**CHARLOTTE - MECKLENBURG**  
**PLANNING COMMISSION**

**SUBJECT:** Administrative Approval for Petition No. 82-14(c), Coffey Creek Business Park.

**DYE-CHEM INTERNATIONAL**  
 A NEW OFFICE/WAREHOUSE FOR  
**COFFEY CREEK BUSINESS PARK**

82-14(c)  
 ATTACHED TO ADMINISTRATIVE APPROVAL  
 DATED: December 13, 1999  
 BY: MARTIN R. CRAMTON, JR.

**PROPOSED SITE PLAN**

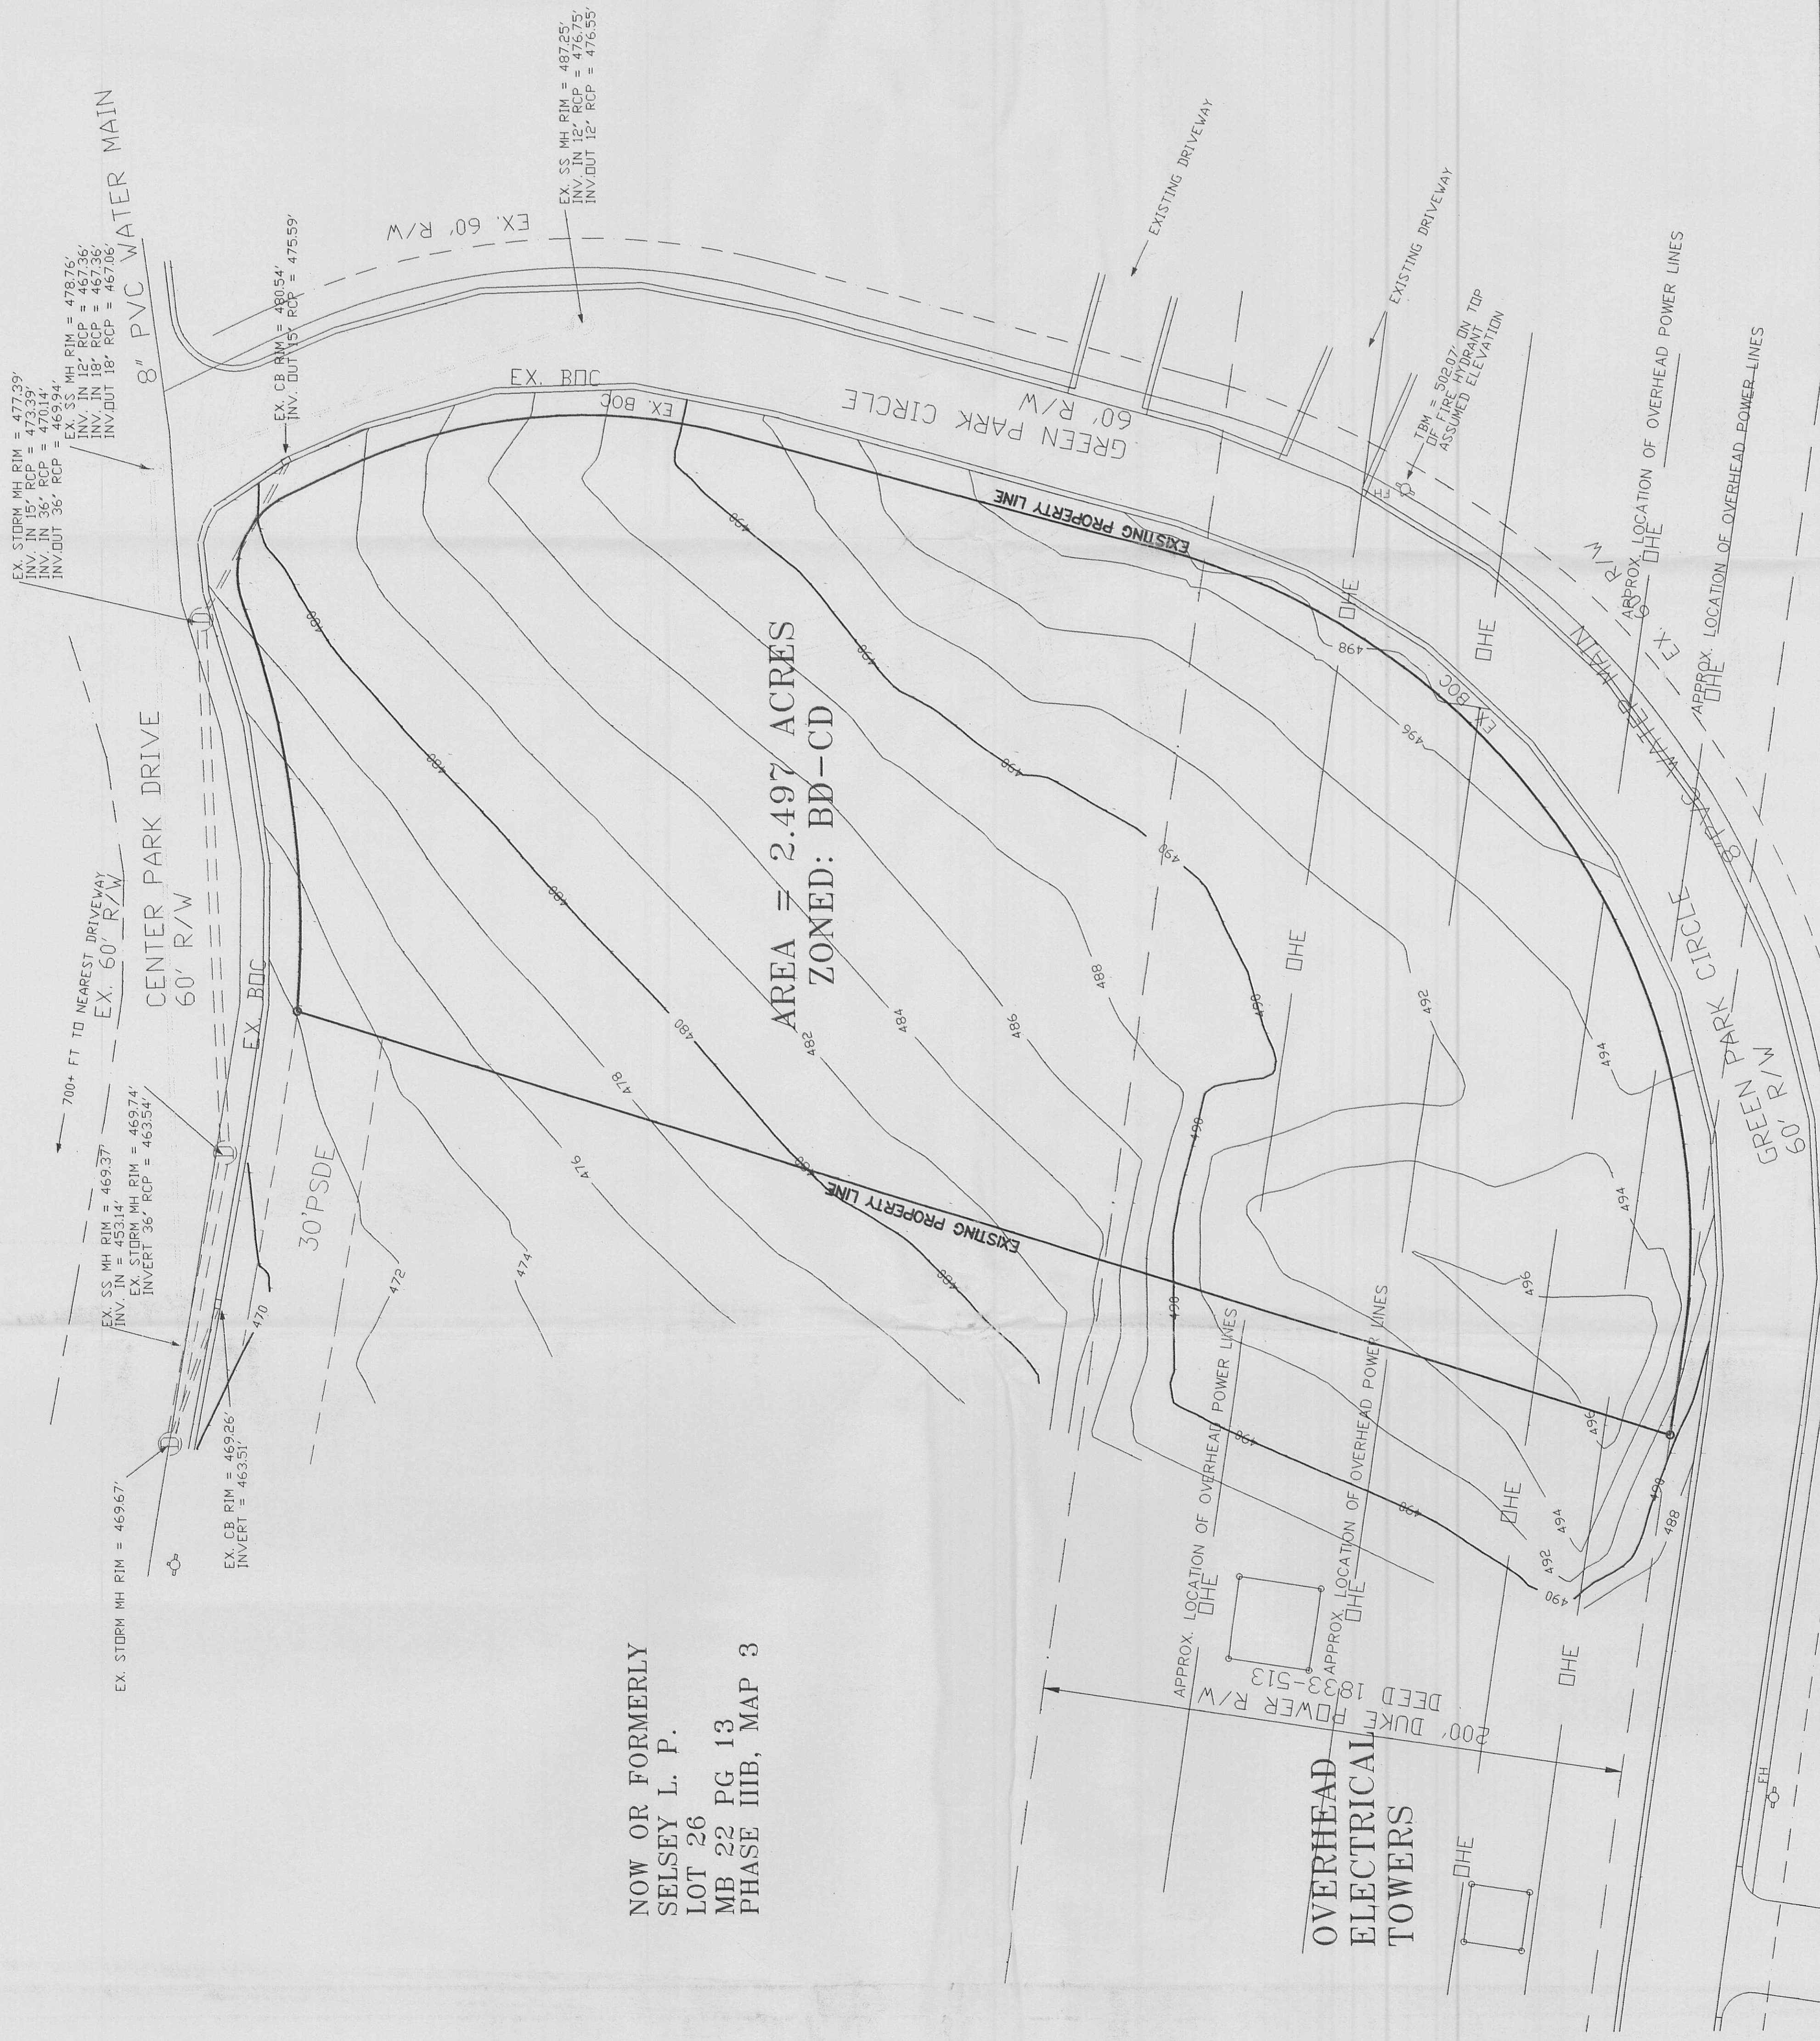
Attached is a site plan for the Dye-Chem International site located in the Coffey Creek Business Park. The plan indicates a reduction in the required 15-foot separation between the building and parking. Since this change is minor, I am administratively approving this revised plan. Please use this revised plan when evaluating requests for building permits and certificates of occupancy.

**PROPOSED SITE PLAN**

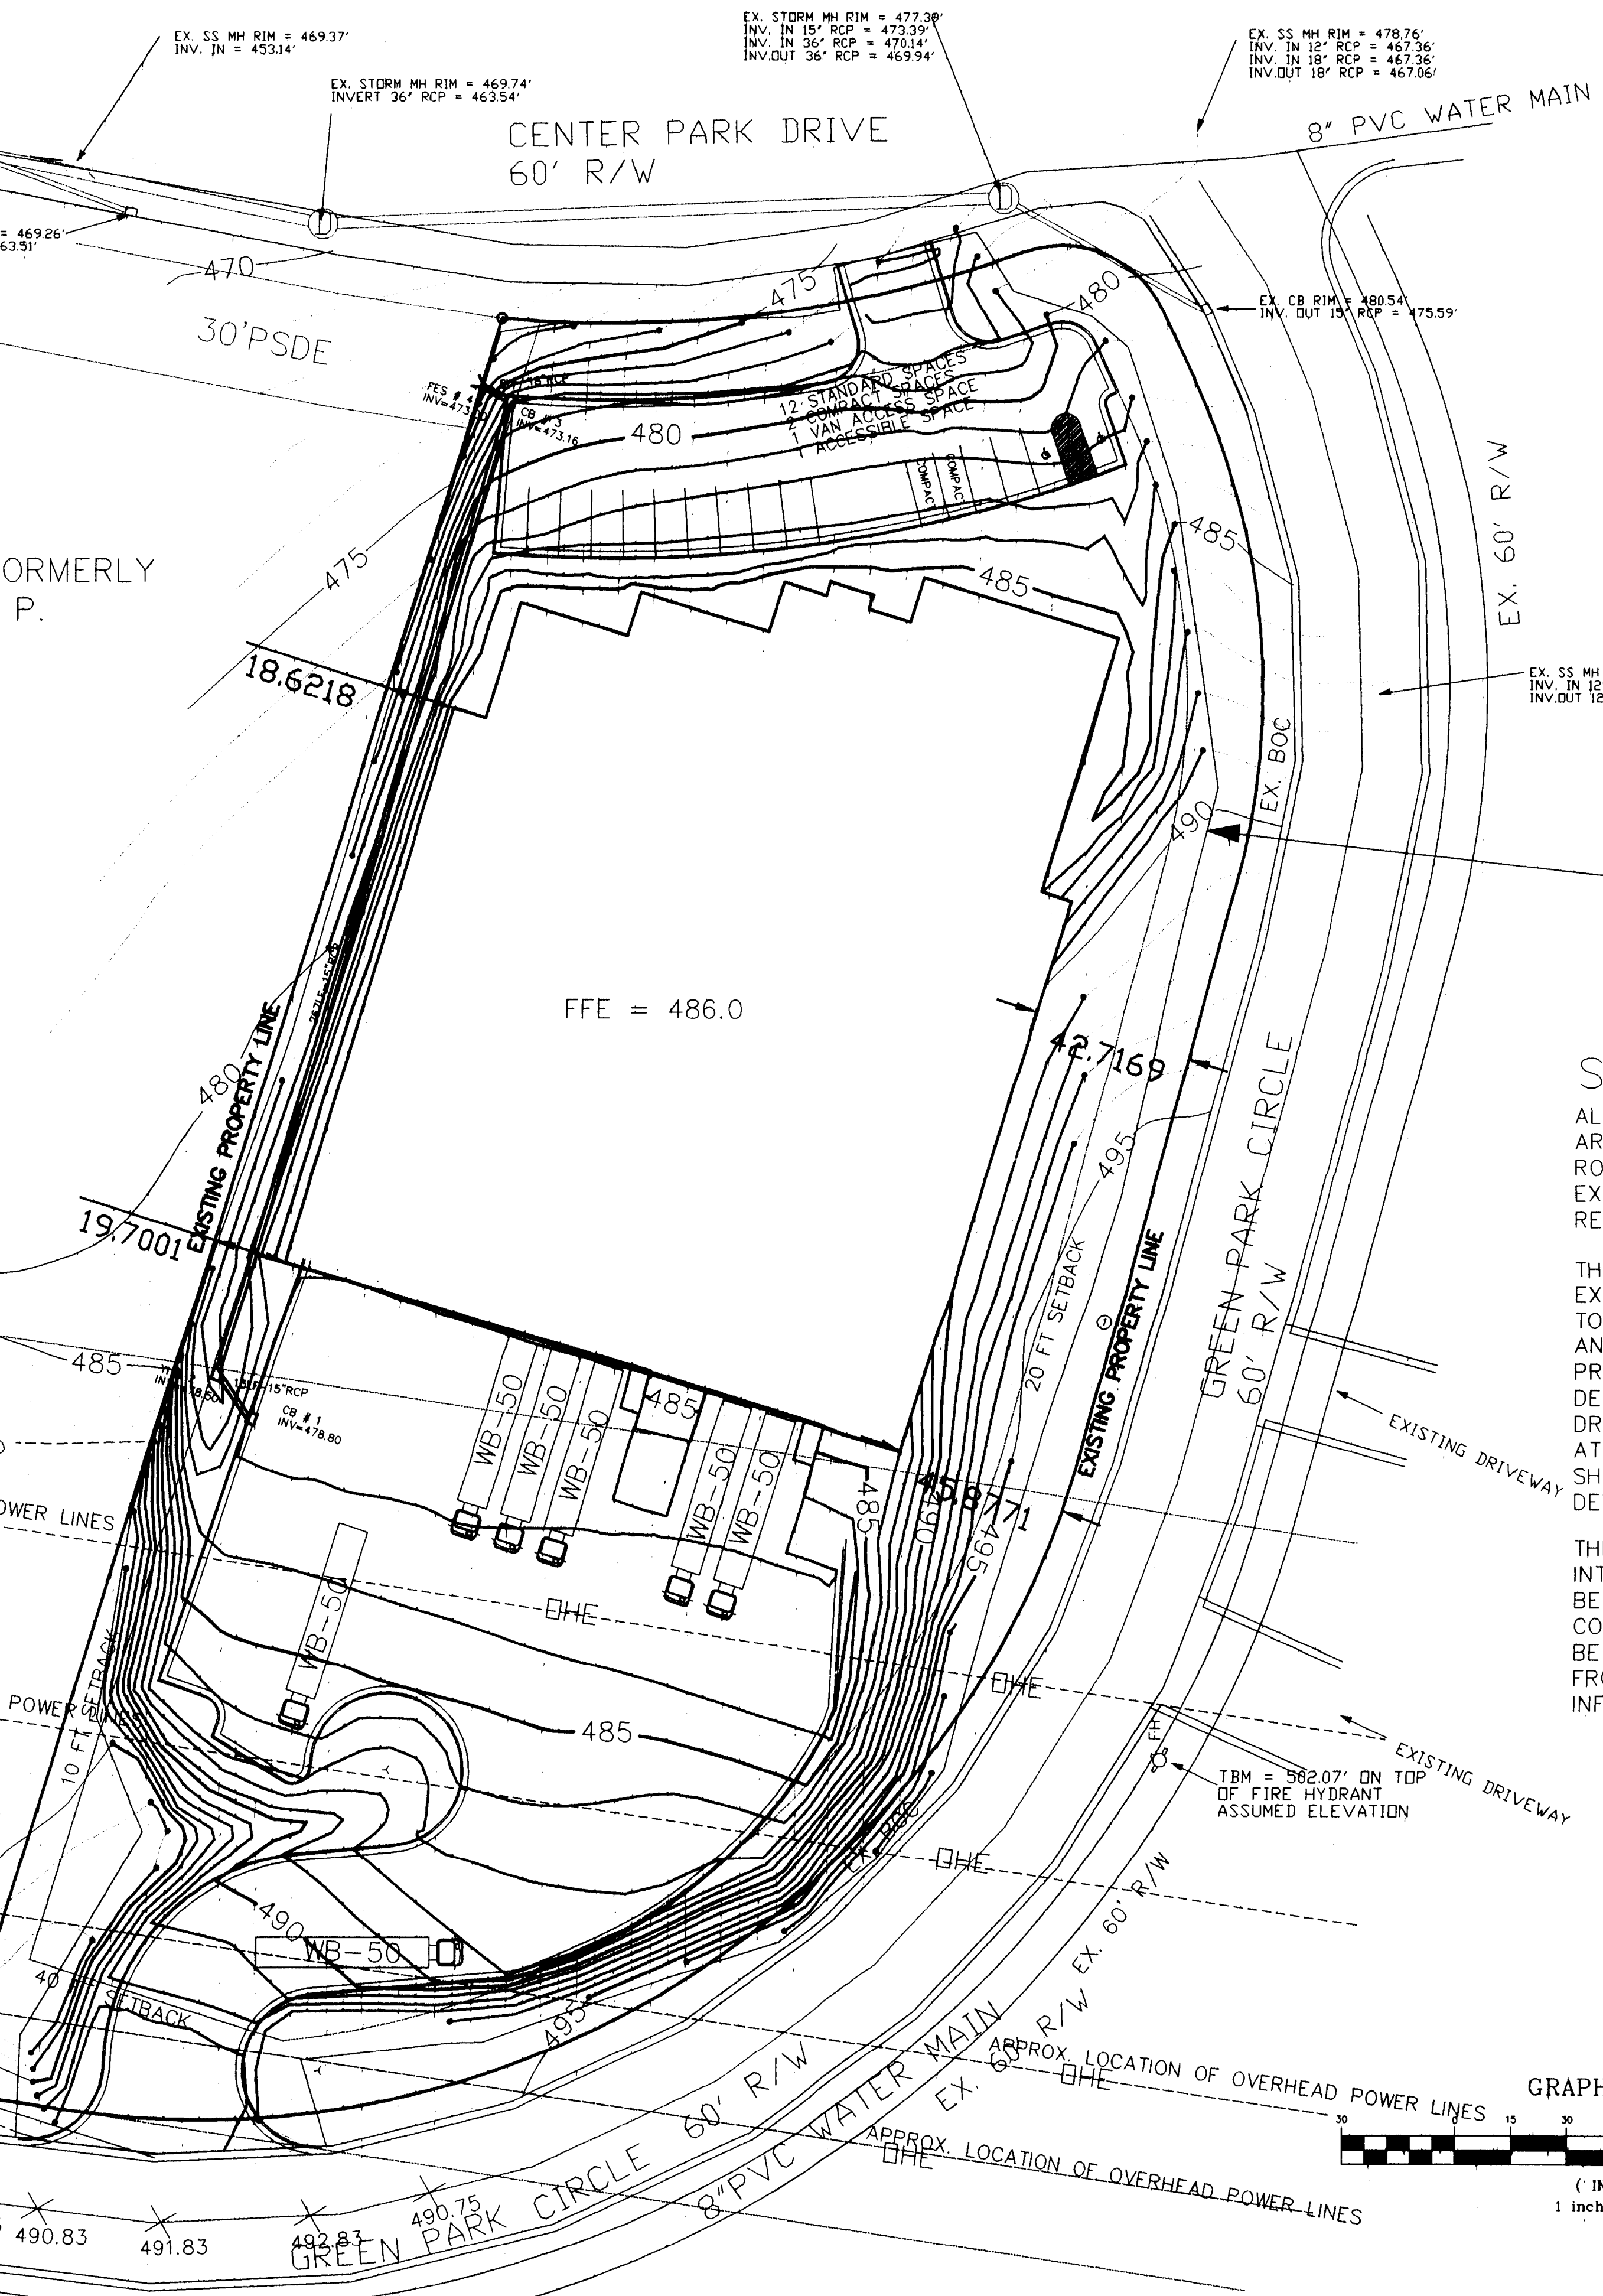
Attached is a site plan for the Dye-Chem International site located in the Coffey Creek Business Park. The plan indicates a reduction in the required 15-foot separation between the building and parking. Since this change is minor, I am administratively approving this revised plan. Please use this revised plan when evaluating requests for building permits and certificates of occupancy.
